MATHER AFB CALIFORNIA

SUBJECT: Final Fifth Five-Year Review Report, former Mather Air Force Base (AFB),

**FIFTH FIVE-YEAR REVIEW REPORT
FORMER MATHER AIR FORCE BASE
SACRAMENTO COUNTY, CALIFORNIA**

Figure 5-3

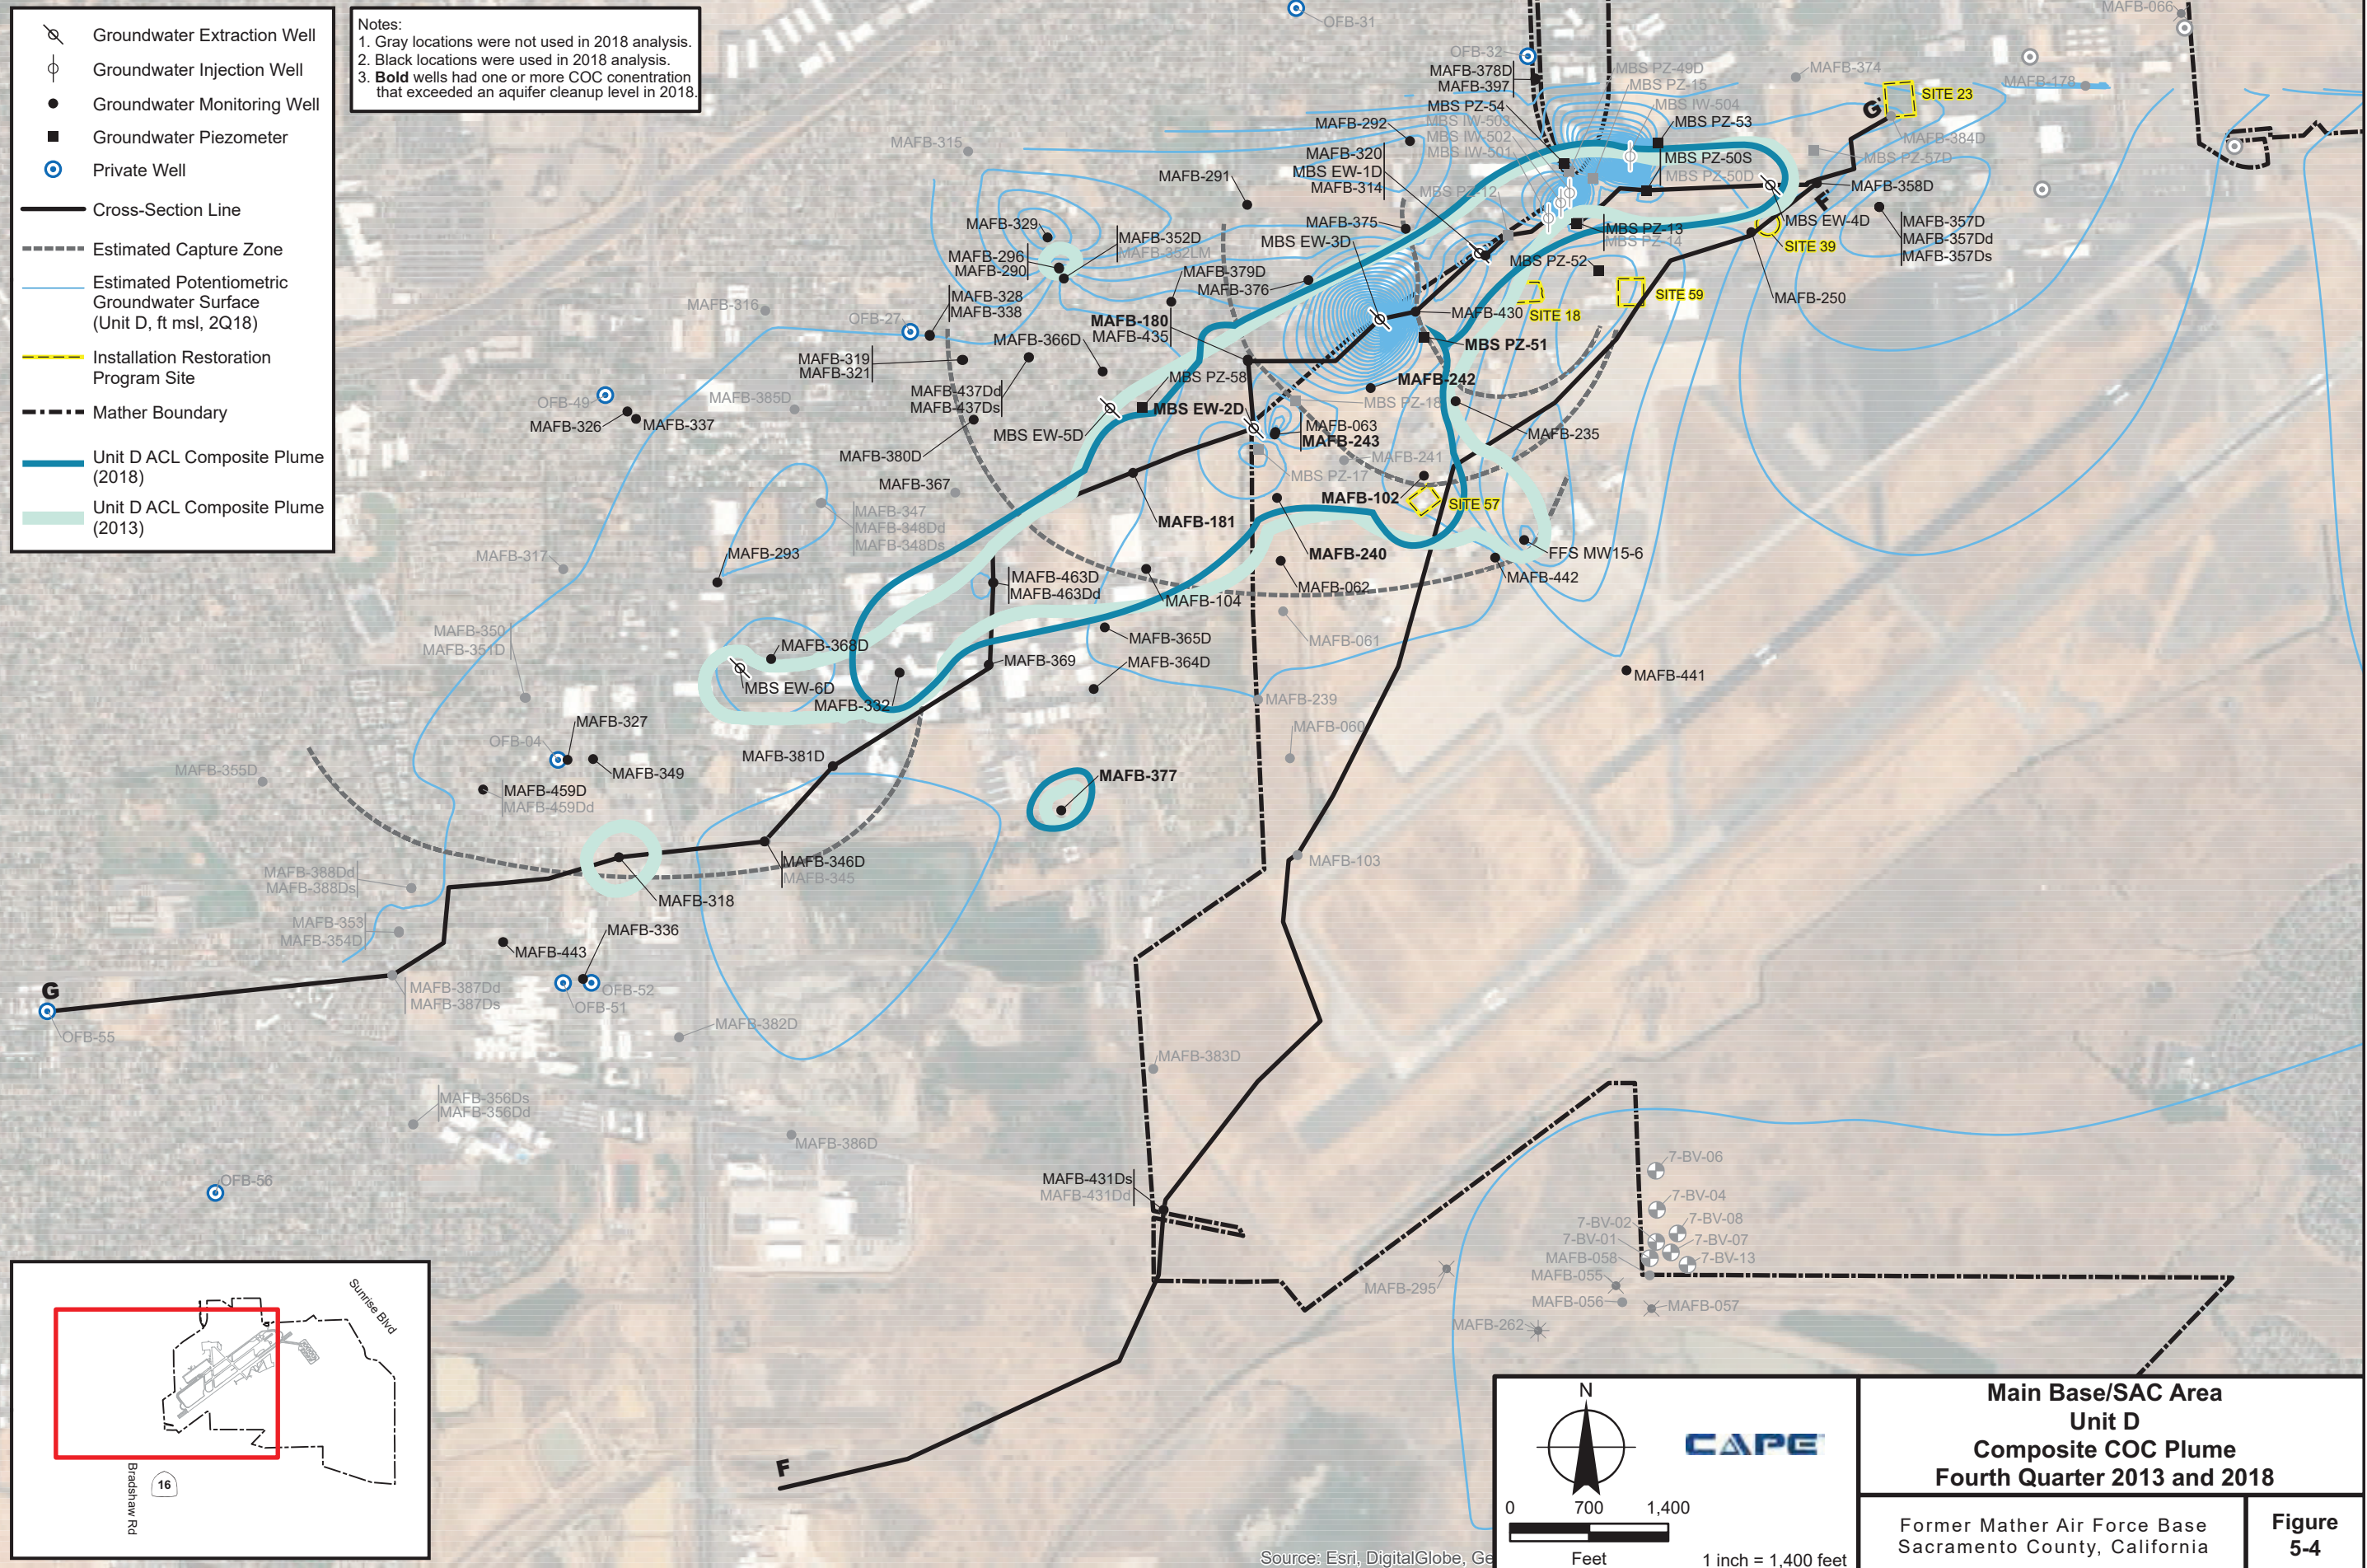
75. **PDF Page 61 (5-9), Section 5.3.1.1, Question A, Is the Remedy Functioning as Intended by the Decision Documents, Progress Toward Meeting RAOs, and Figure 5-3, Main Base/SAC Area Unit B Composite COC Plume, Fourth Quarter 2013 and 2018:** The Progress Toward Meeting RAOs section for OU 2 states that a majority of the plume has been captured but does not discuss future plans for capture of the Unit B Composite Plume that appears to be uncaptured, as shown on Figure 5-3. Figure 5-3 appears to indicate the plume is migrating towards the east and southeast, but no additional monitoring wells are located beyond MAFB-423B and MAFB-451 to delineate the extent of the plume. It is unclear how this potential migration will be addressed and how current monitoring activities are sufficient to meet RAOs if the plume extends beyond well MAFB-423B and MAFB-451. Further it appears that MBS EW-2Bu and MBS EW-9B, the nearest extraction wells to the east and southeast portions of the plume, are located outside the plume boundary to the west and are not capturing the plume. An extraction well is needed in the center of the large plume shown on Figure 5-3. Please discuss the progress towards meeting RAOs for the Main Base/SAC Area plume considering that the eastern and southeastern edges of the plume have not been defined or captured, as shown on Figure 5-3.
